ADDENDUM #01

ADA Compliance Upgrades Foussat and Libby

BID NO. 2025-21-070B

RFI #1: DWG Review - ADA Scope

Sheet - C1.5 - Photos of the parking lot already have striping and signs.

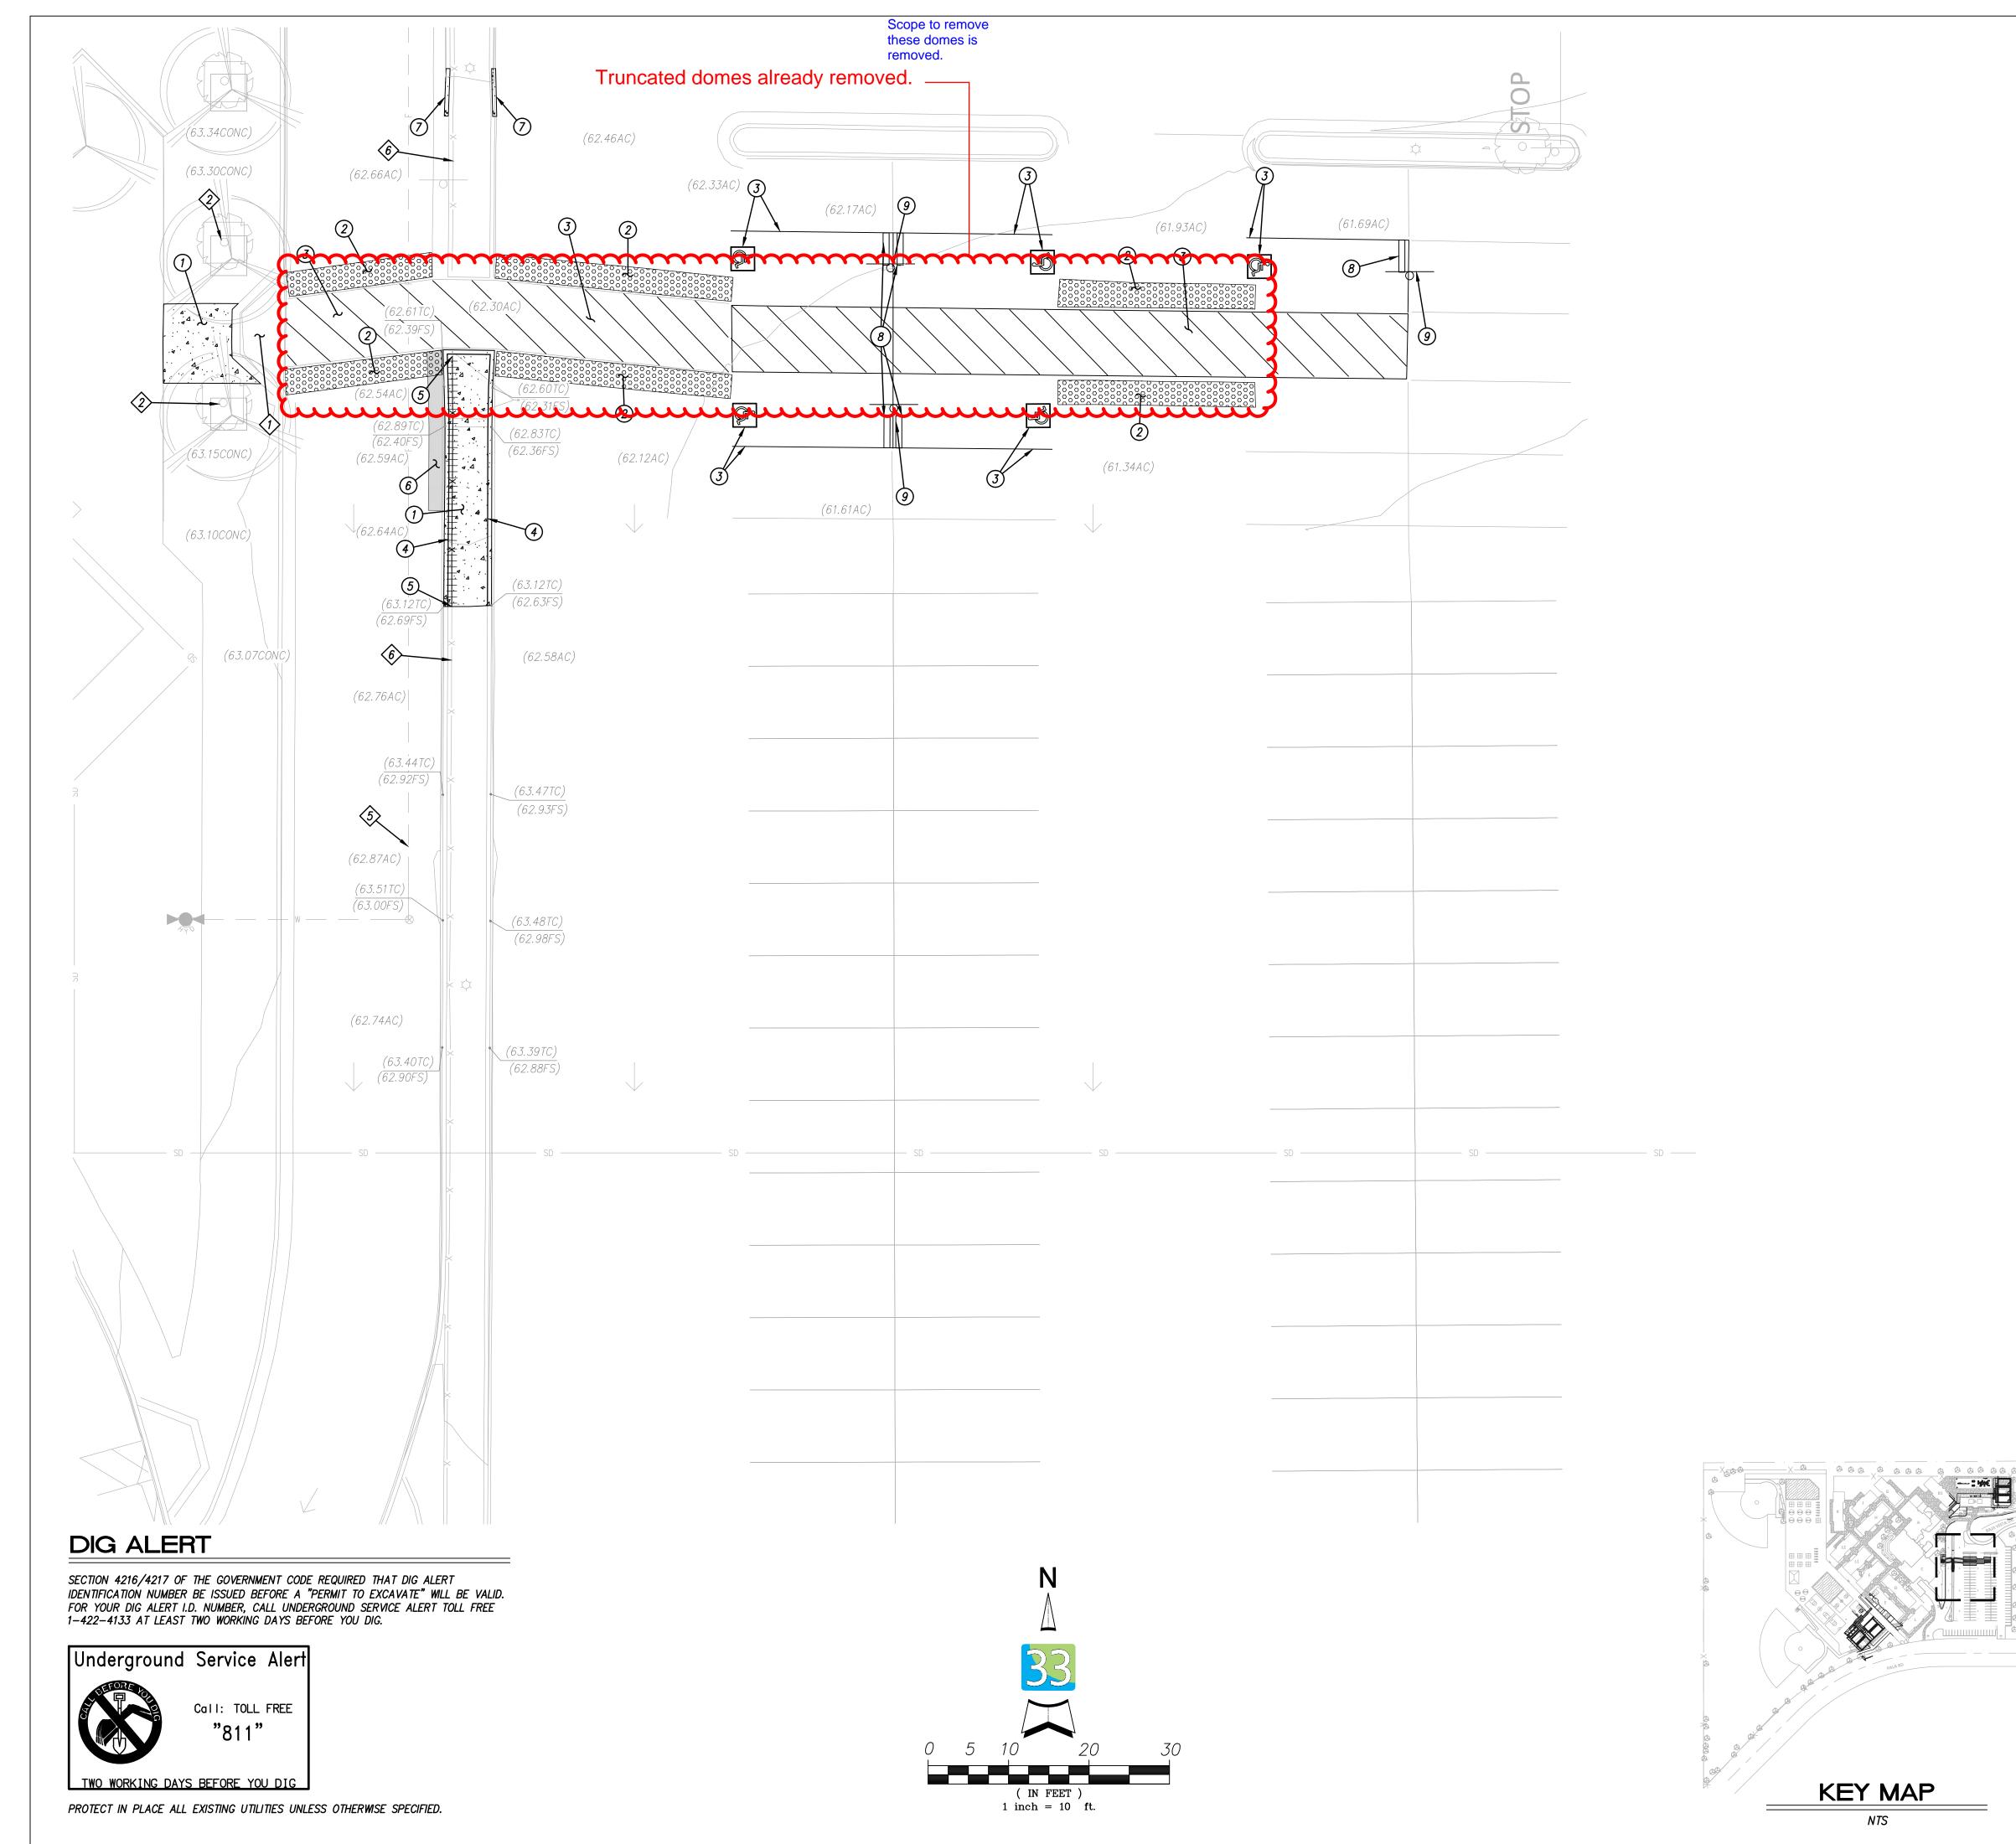
Sheet - C1.5 - Photos of the parking lot already have striping and signs. Questions:
	 Detail 2 - Is the 3' spacing a hard dimension? I have about 2'5" from edge of wheel stop to the striping. (Which is about where the ADA sign is located.) Maybe the 3' is based on the spacing between the two wheel stops not the striping like I measured, please let me know. Detail 3 - Does the ADA Parking stencil need to be solid white at the edges, the existing has spaces.

- 1. Detail 2 Is the 3' spacing a hard dimension? I have about 2'5" from edge of wheel stop to the striping. (Which is about where the ADA sign is located.) Maybe the 3' is based on the spacing between the two wheel stops not the striping like I measured, please let me know. Yes.
- 2. Detail 3 Does the ADA Parking stencil need to be solid white at the edges, the existing has spaces. Yes.
